PLAN AND ZONING COMMISSION MEETING

CITY OF DAVENPORT, IOWA

Subject:
Case F26-08: Request of 53rd Luxury LLC for a Final Plat of Speer Commercial Park 3rd Addition. The 5-lot subdivision is located at 1777 East 53rd Street, on 28.3 acres. [Ward 8]

# SPEER COMMERCIAL PARK 3RD ADDITION

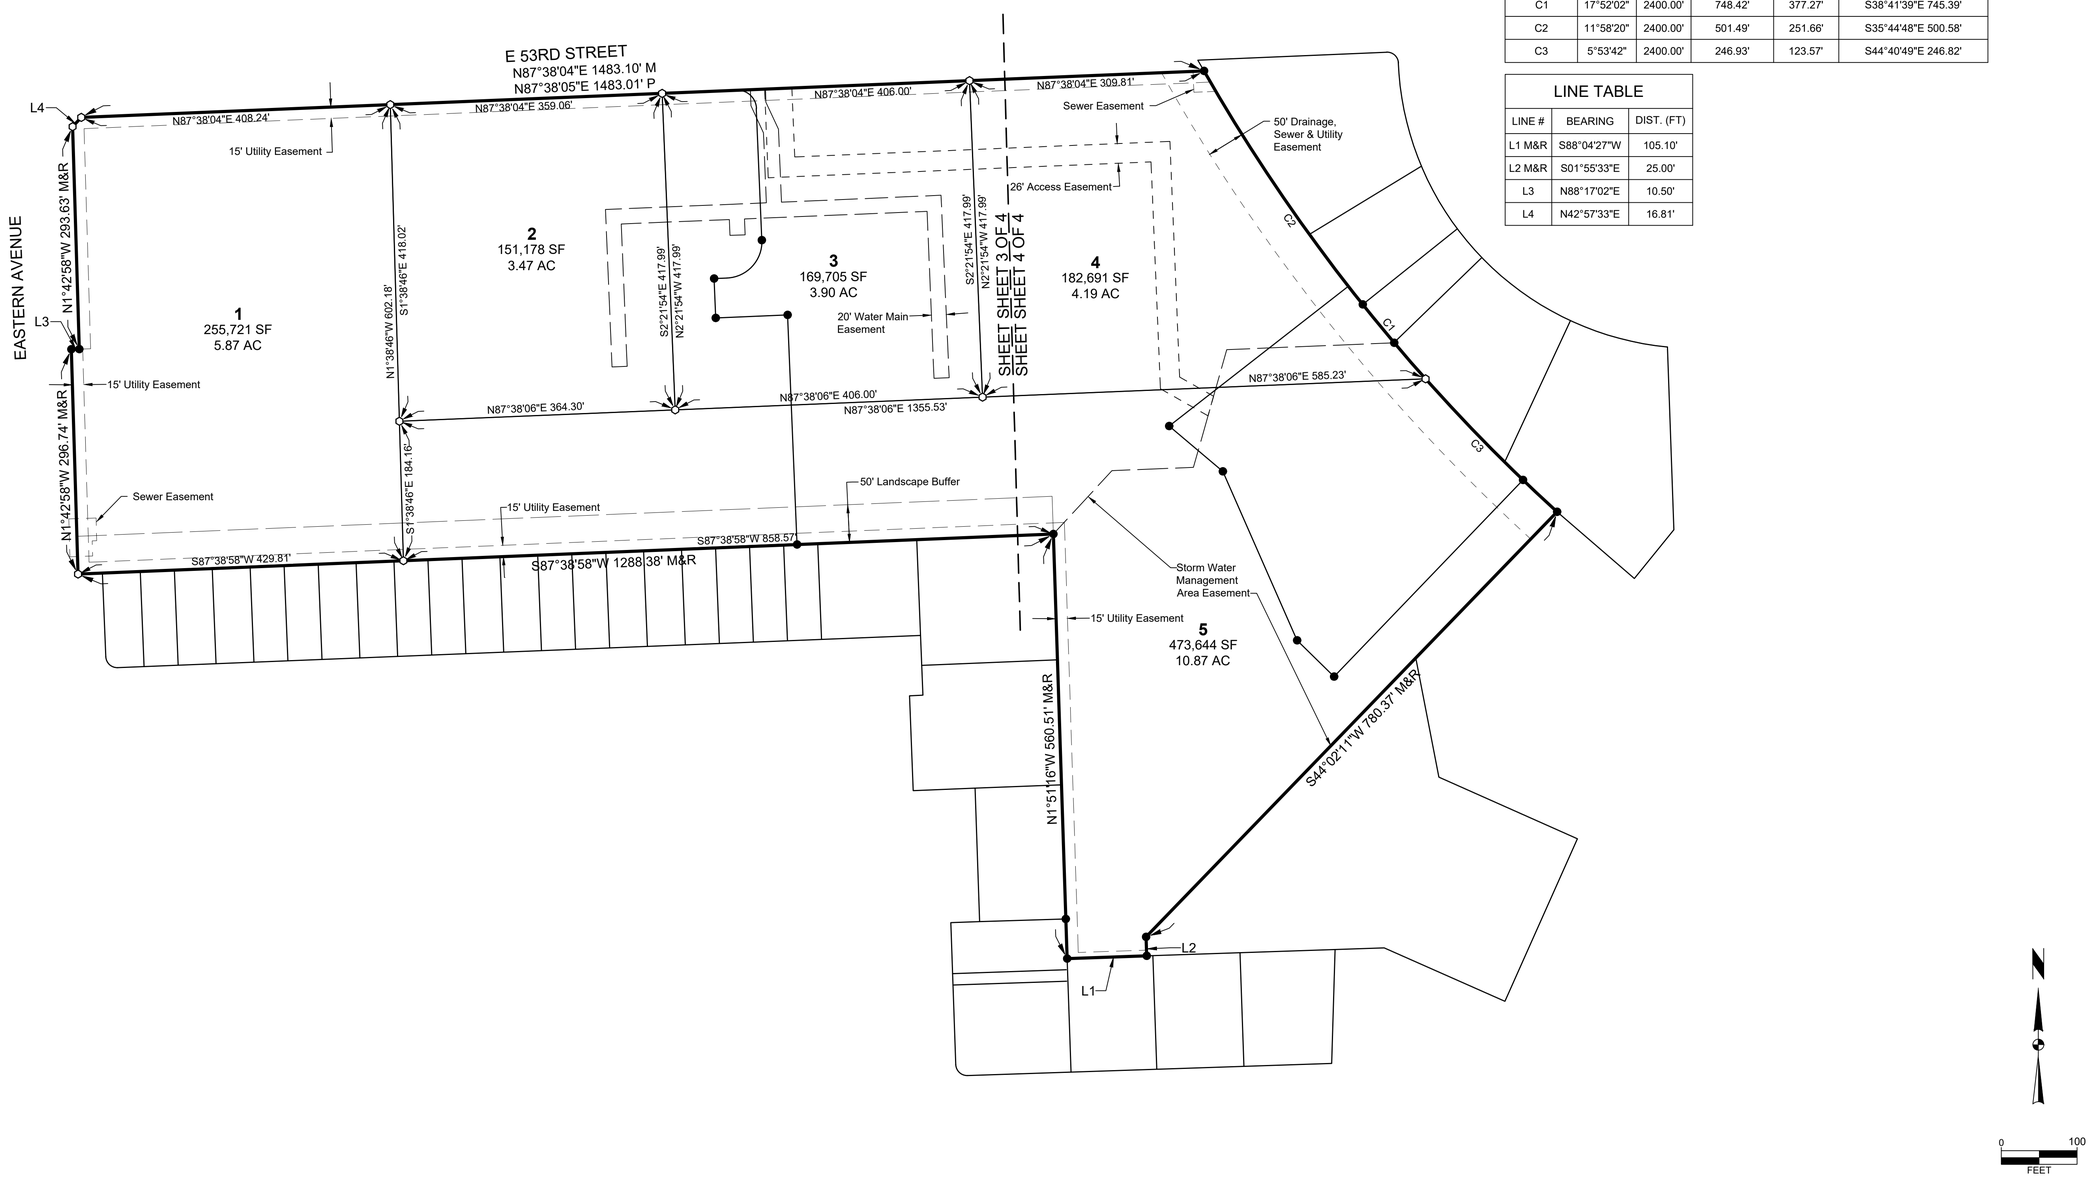
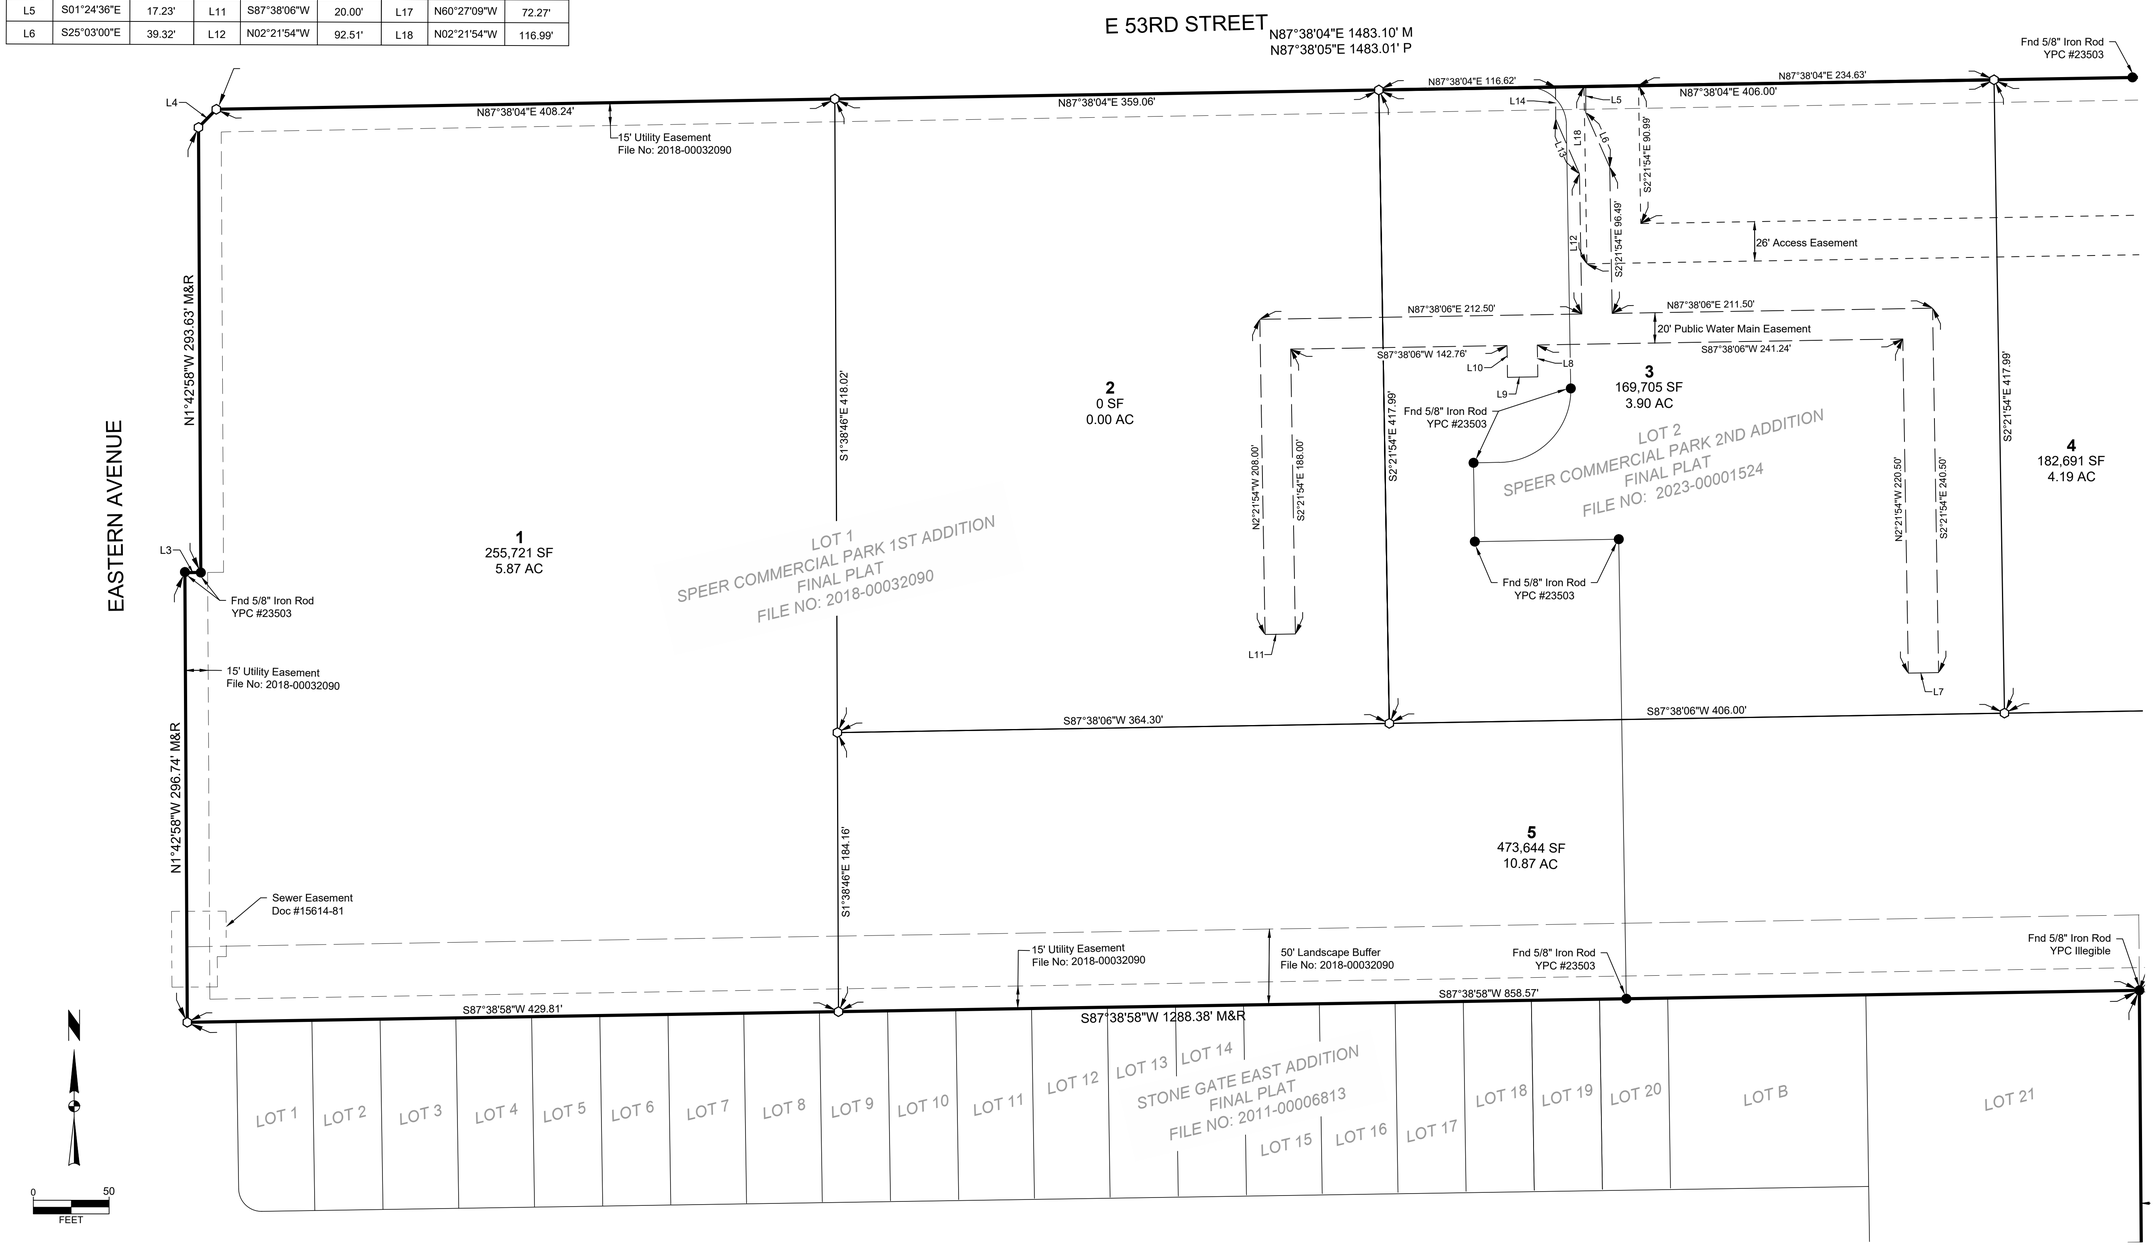
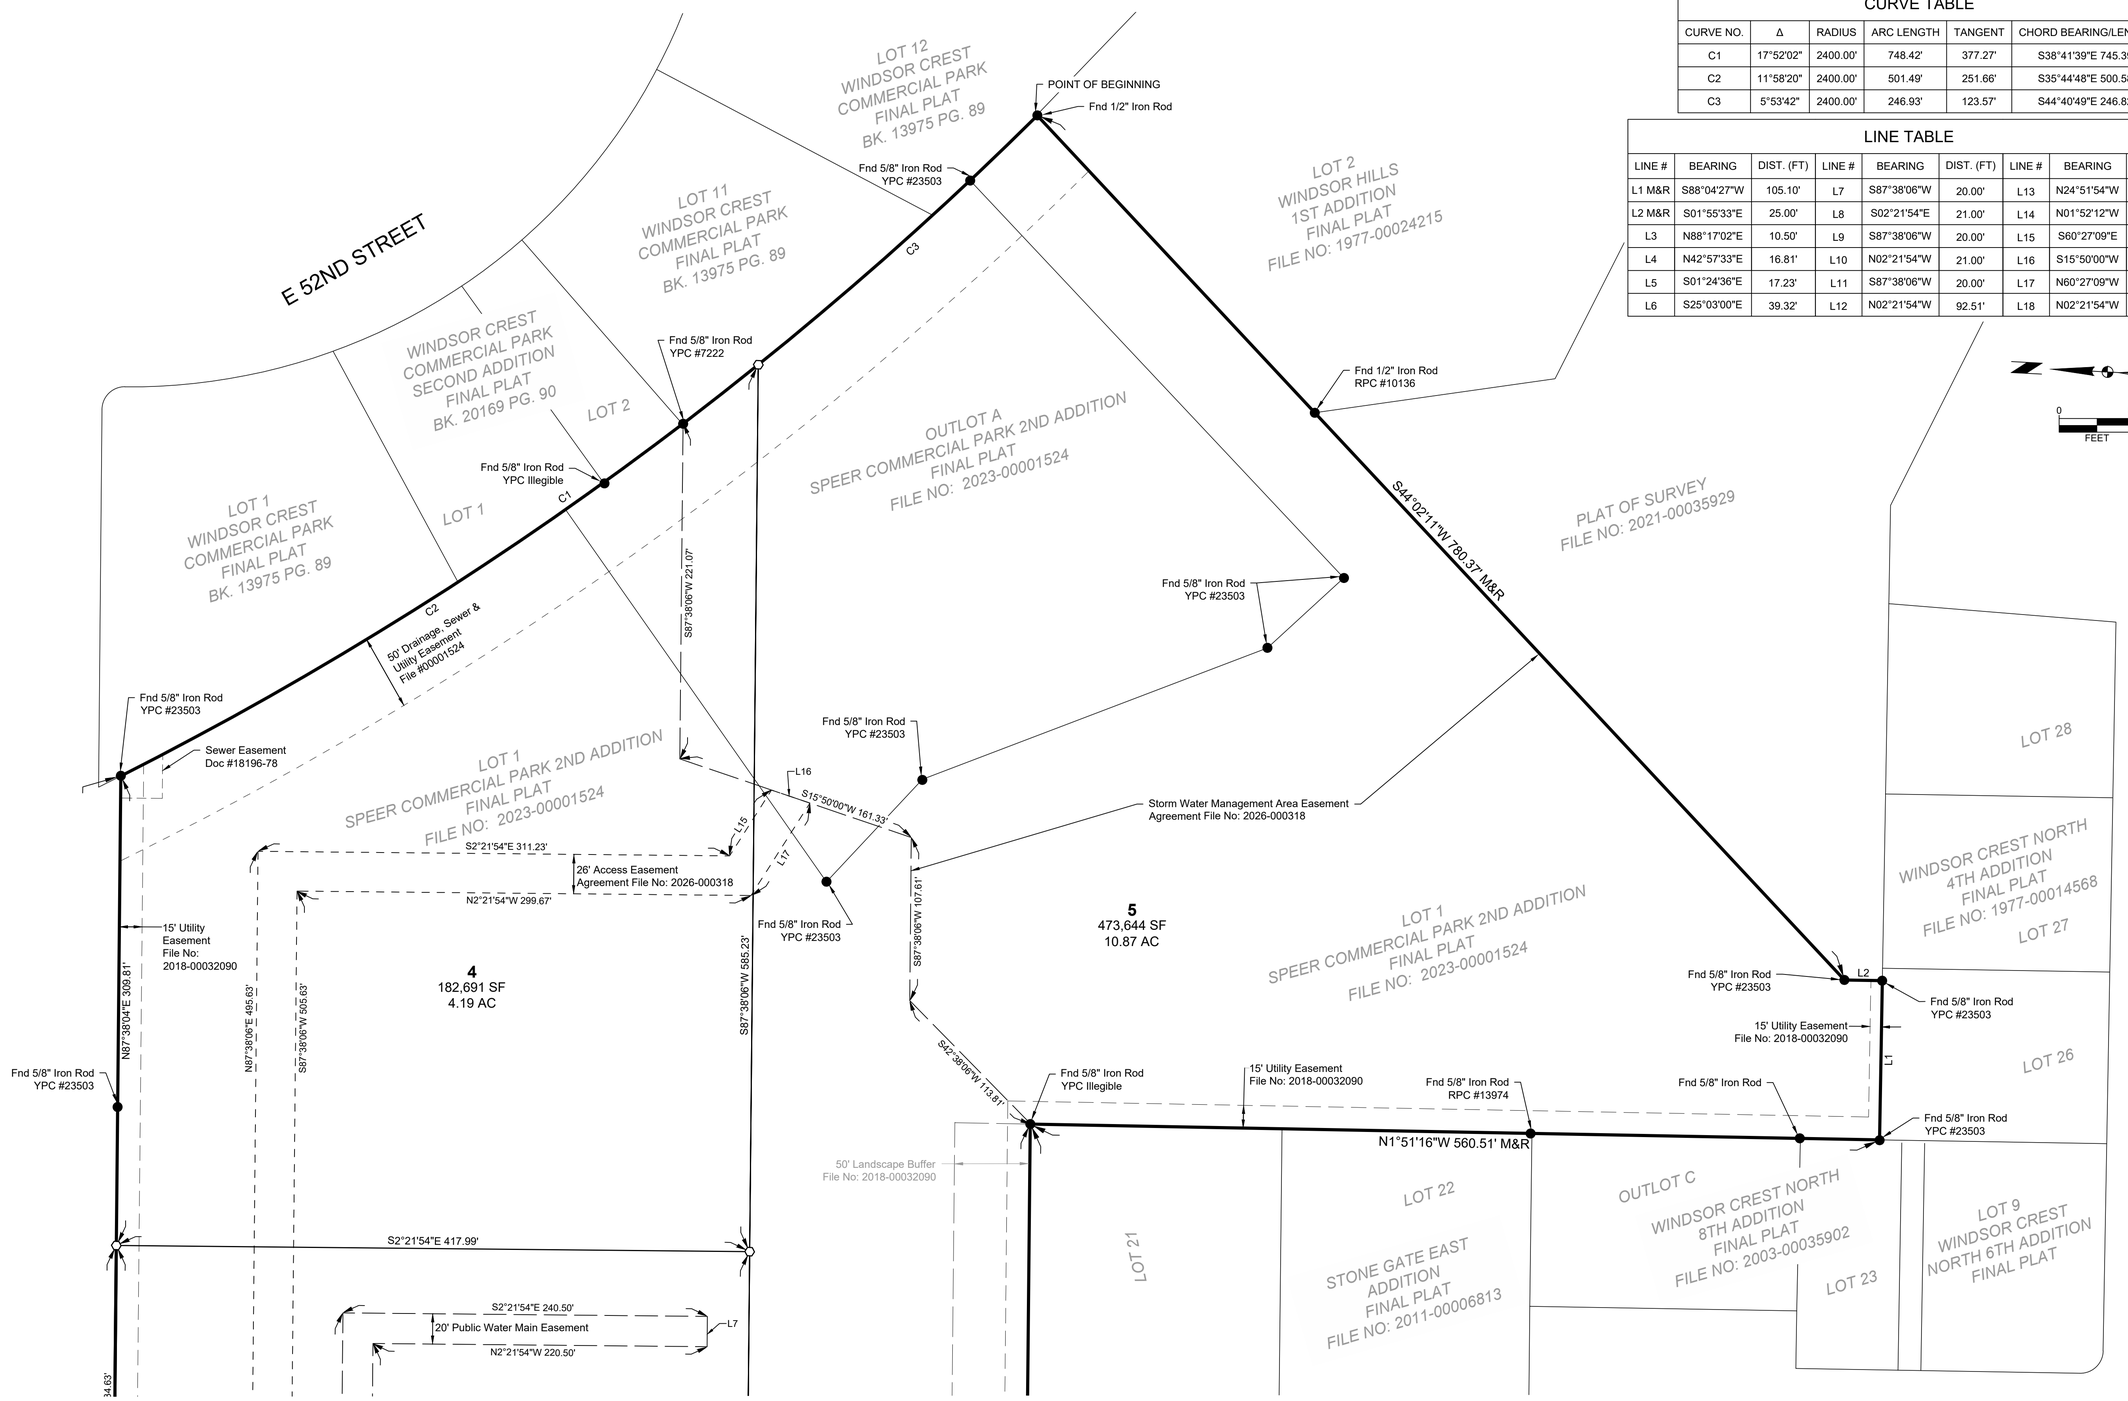
1. That the surveyor signs the plat.
2. That the utility providers sign the plat when their easement needs have been met.
3. Add the following note to the plat: "The property is zoned C-3 General Commercial District and is subject to the conditions established by Ordinance No. 2023-436."
4. Add the following note to the plat: "Development of the platted area shall be in compliance with the approved Special Use Permit on file with the City of Davenport."
5. Provide the City with Maintenance and Repair Agreements for all shared access drives and storm sewer infrastructure.
6. Dedication and acceptance of the sanitary sewer infrastructure shall be completed prior to recording of the final plat.
7. Include final wetland delineation extents on the final plat.

3. Stormwater: The final plat establishes the necessary stormwater management infrastructure through the dedication of a Stormwater Management Area Easement and associated drainage easements. Existing stormwater facilities were approved as part of the overall site development and are designed to accommodate the subdivision as proposed. No additional public stormwater improvements are required with approval of the final plat. However, the plat shall be revised to include the final wetland delineation extents.

4. Sewer System: The property is served by existing public sanitary sewer infrastructure located within East 53rd Street and the Hanlin's Creek corridor. Due to the proposed lot configuration, the existing sanitary sewer serving the development is required to be dedicated to the City as public infrastructure. City staff are coordinating with the developer to verify that the installed sewer improvements conform to City standards and are eligible for public acceptance. Dedication and acceptance of the sanitary sewer infrastructure shall be completed prior to recording of the final plat.
